Product Change Notification

PCN-ICC-5780-2020

Business Unit	Product Line Code	Type of Change	Action	Date of Issue
ICC - Industrial Cabinet	BE2	Product Change Notification	Notify Distributors and Field	11/3/2020

Previous Product	New Product
<p data-bbox="506 464 727 499"><u>current design</u></p>  	<p data-bbox="1295 491 1484 527"><u>future design</u></p>

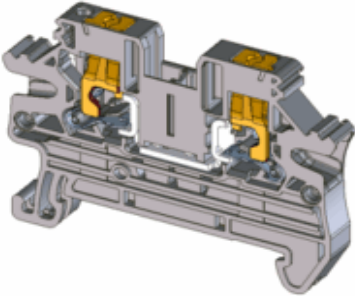
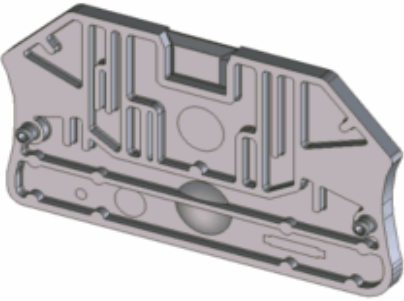
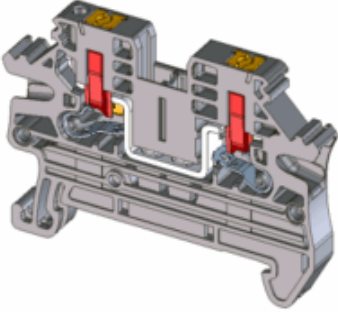
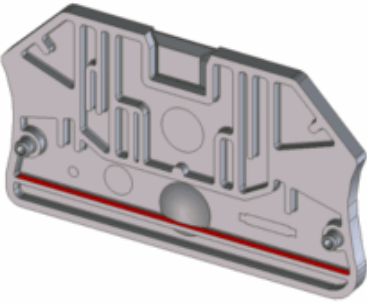
To optimize the PTV series, the PTV 2.5 portfolio will receive a small modification on the pusher to improve operation of the terminal block. The bridging channel has also been optimized, changing from a stamped hole to a rim hole. The technical data nor function of the bridging channel is changed, and is completely functional with the current bridge design. The new PTV 2.5 design will require new end covers, and the old versions will be discontinued later this year. Please see the attached table for more information.
